STATE OF NEVADA
Department of Conservation & Natural Resources
DIVISION OF ENVIRONMENTAL PROTECTION

Re: **Tronox LLC (TRX)**
NDEP Facility ID #H-000539

Nevada Division of Environmental Protection (NDEP) Response to:
*Revised Excavation Plan for Phase B Soil Remediation of RZ-C, Addendum to the
Removal Action Work Plan, Tronox LLC, Henderson, Nevada*

Attachment A

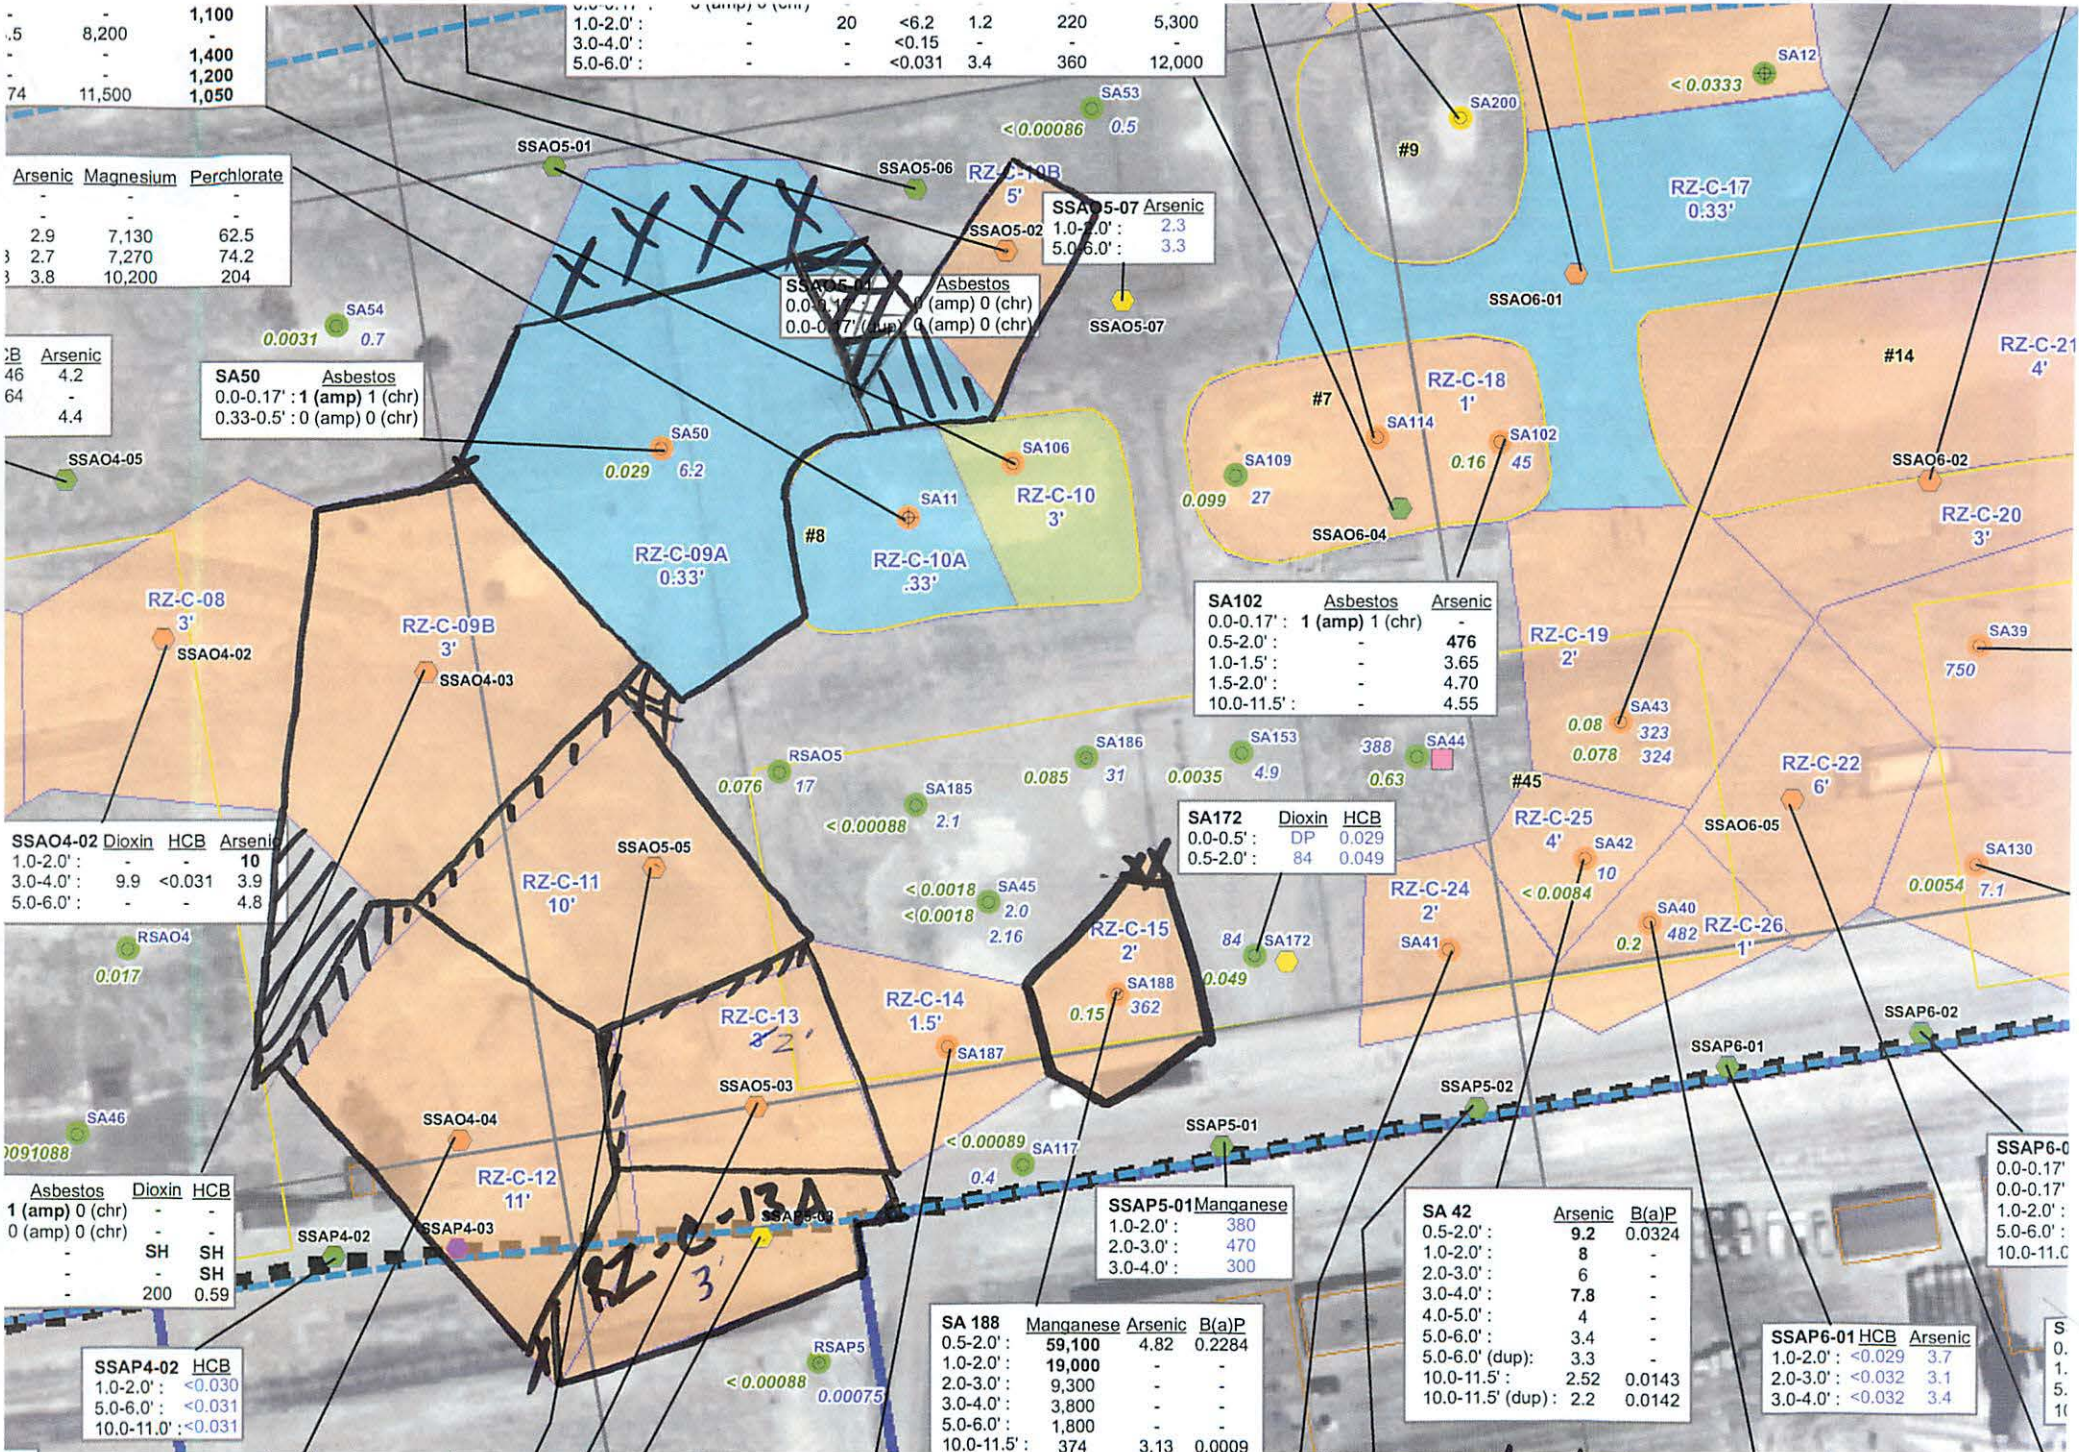
/// additional excavation area

xxx eliminated excavation area

C-4

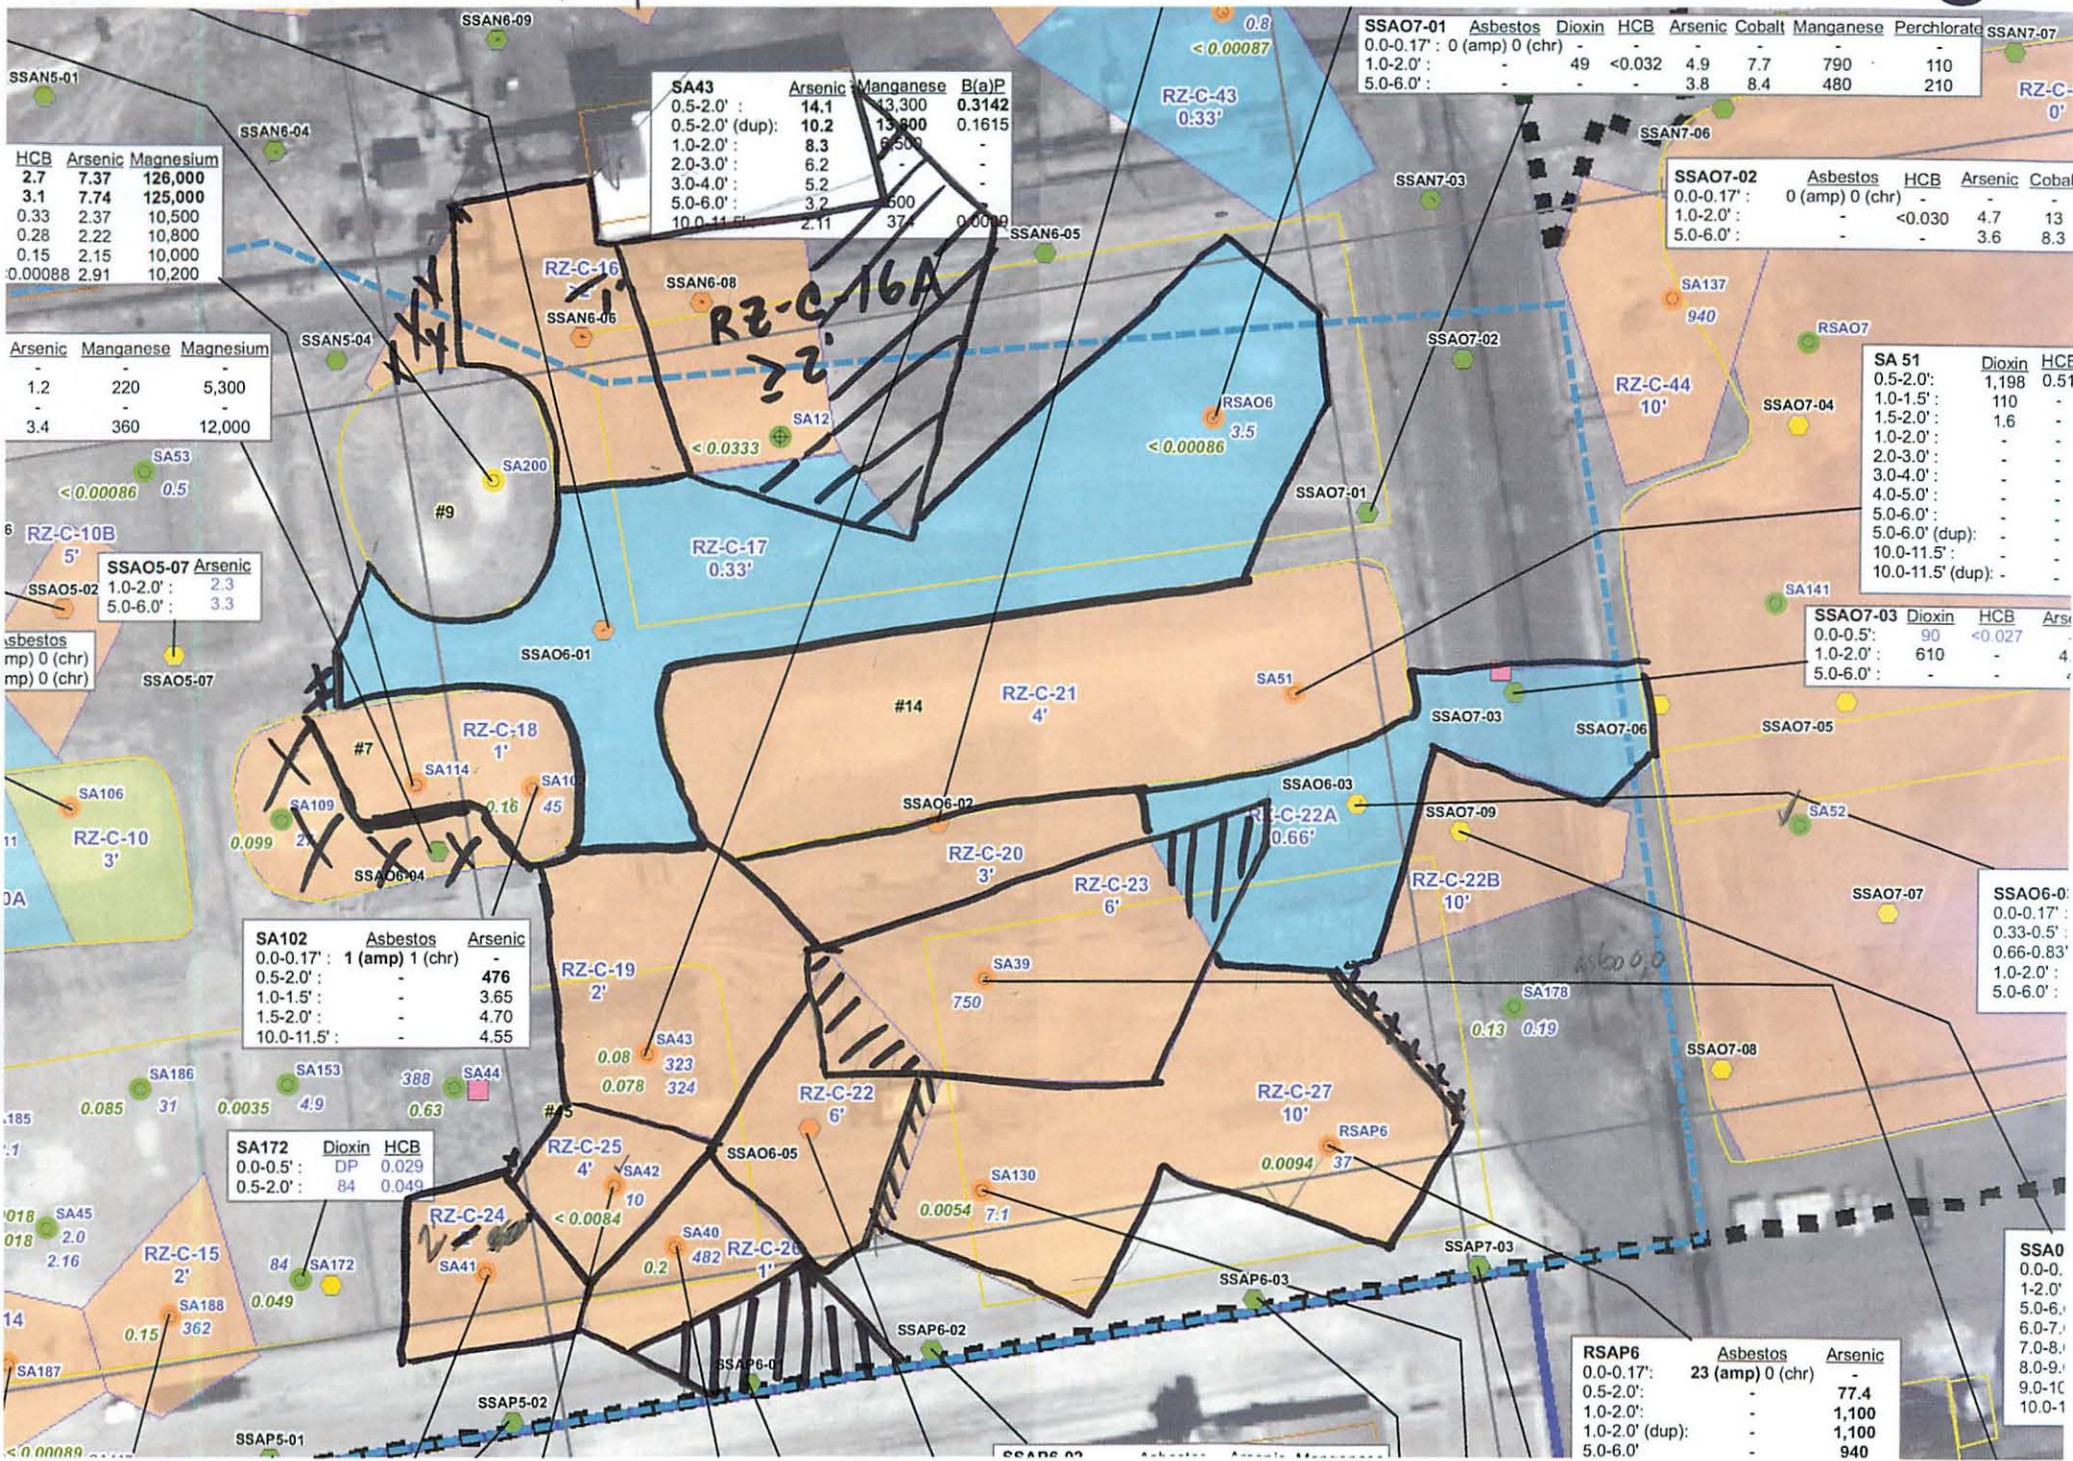
The following Figures are excerpts from Figure 1: RZ-C Excavation Areas and Nature and Extent of Contamination (dated October 12, 2010). NDEP has provided approximate revisions to excavation limits to illustrate the comments made in the Attachment B Table as well as based on comment 2 of Attachment A.

C-8

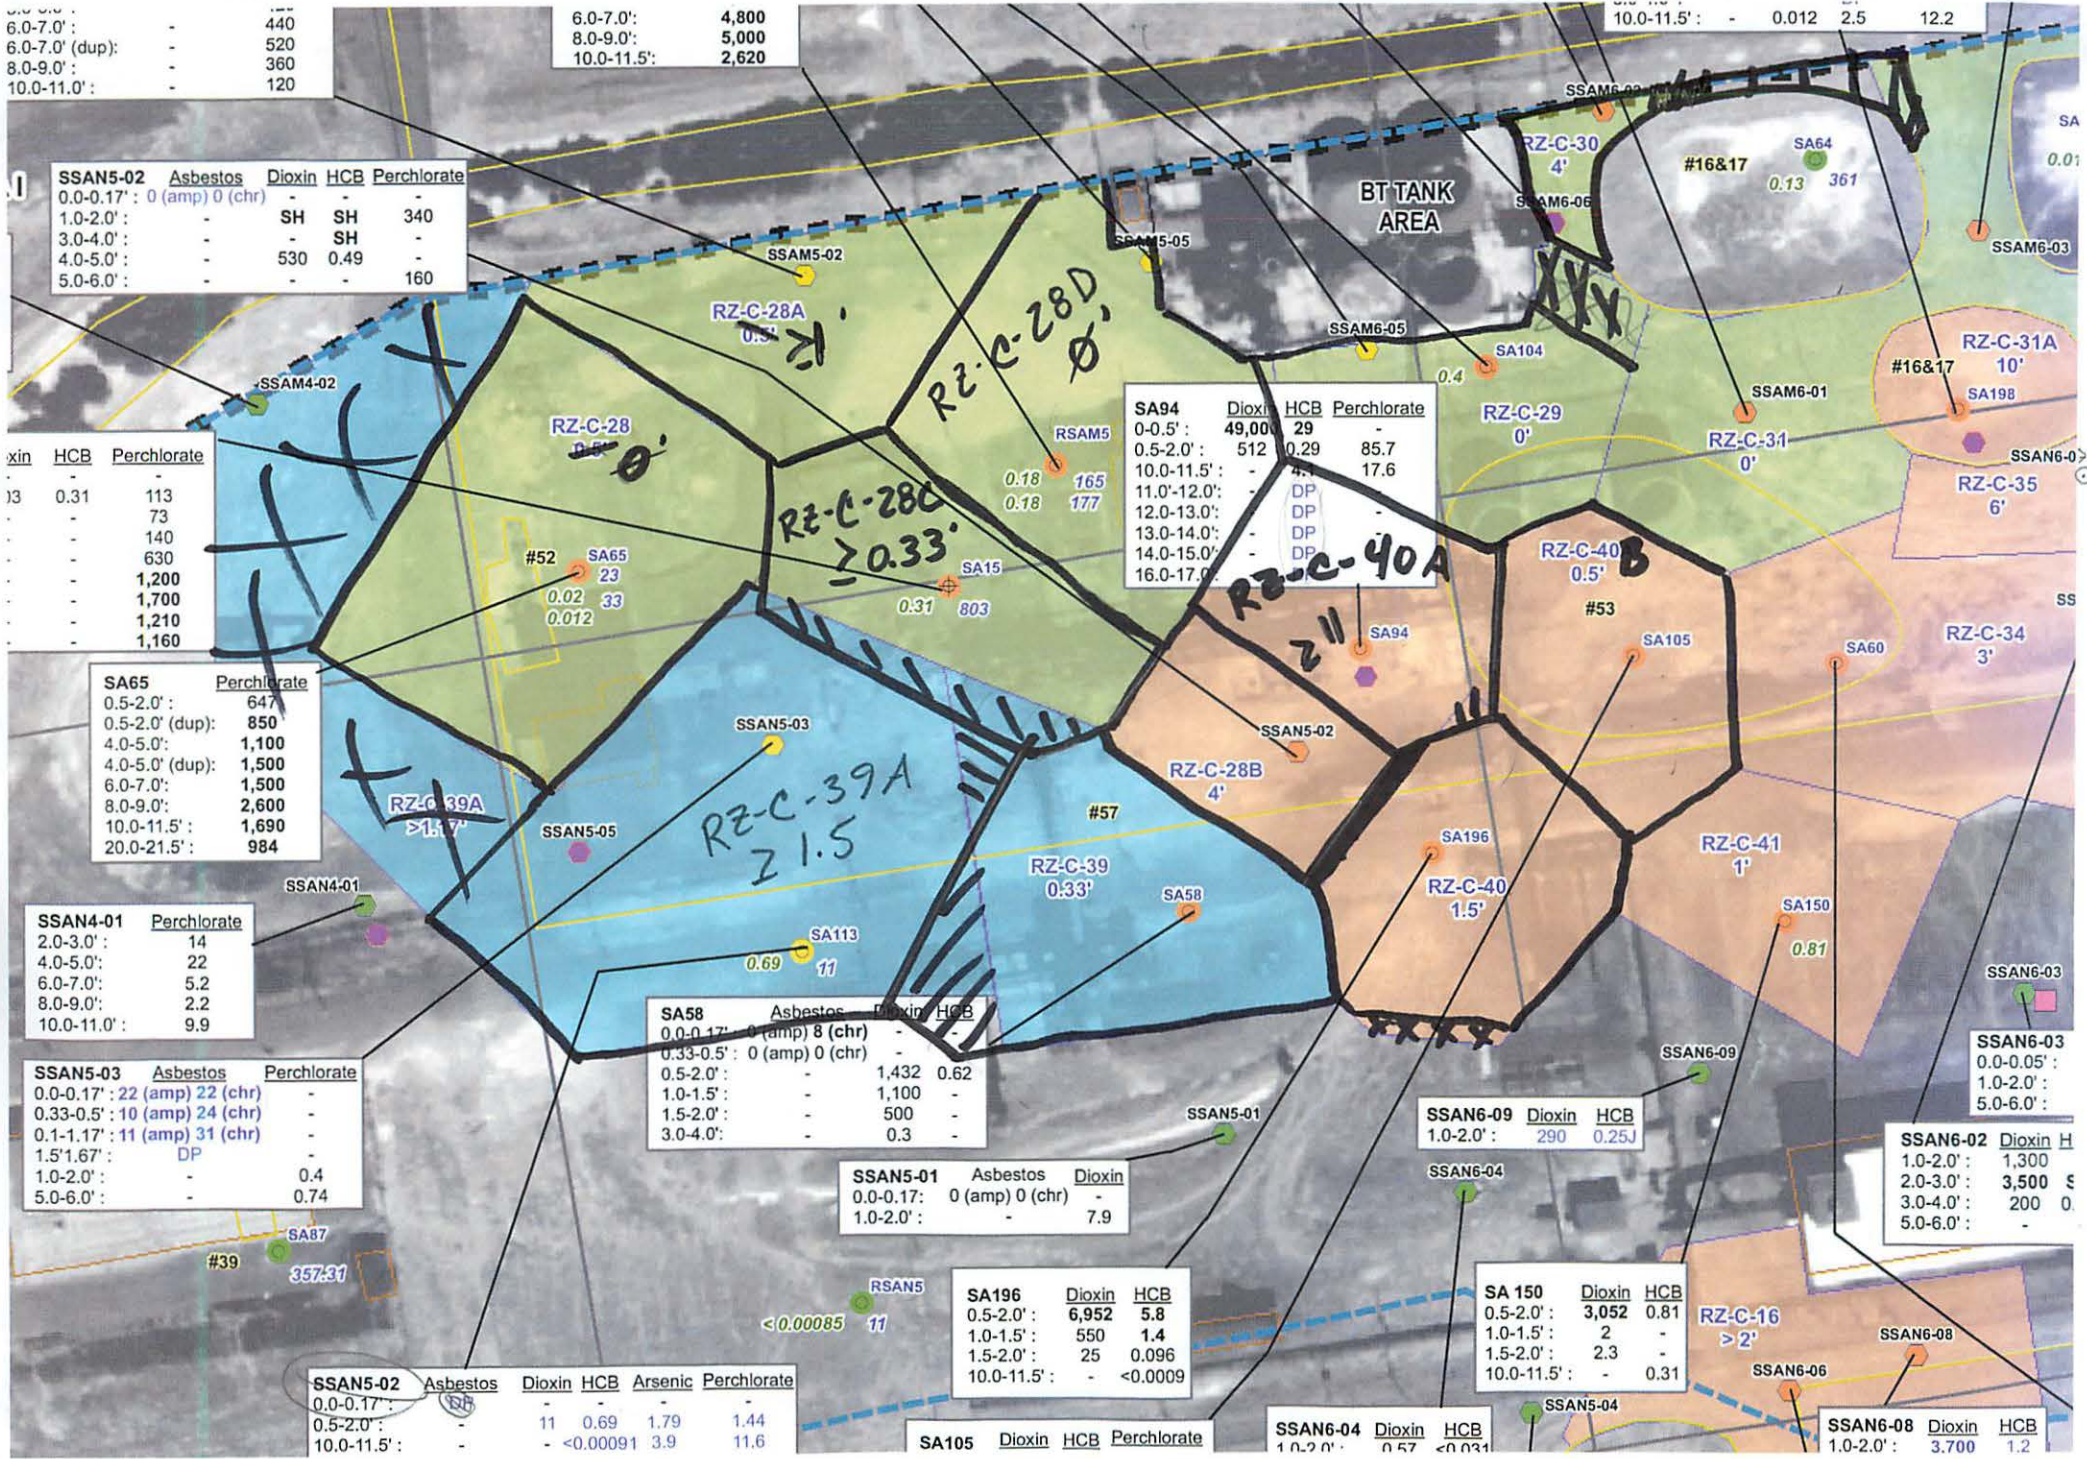
Please note that Figures C-7 and C-8 are included for the revisions that will be necessary once the asbestos results are received for SA113. Figure C-7 is for the scenario where the asbestos results are less than the comparison levels resulting in the reduction of RZ-C-39A. Figure C-8 are for the scenario where the asbestos results are greater than or equal to the comparison levels resulting in the increase of RZ-C-39A.

* if asbestos results for SA113 are \geq comparison levels
 - only RZ-C-28C, RZ-C-39, & RZ-C-39A revised limits shown
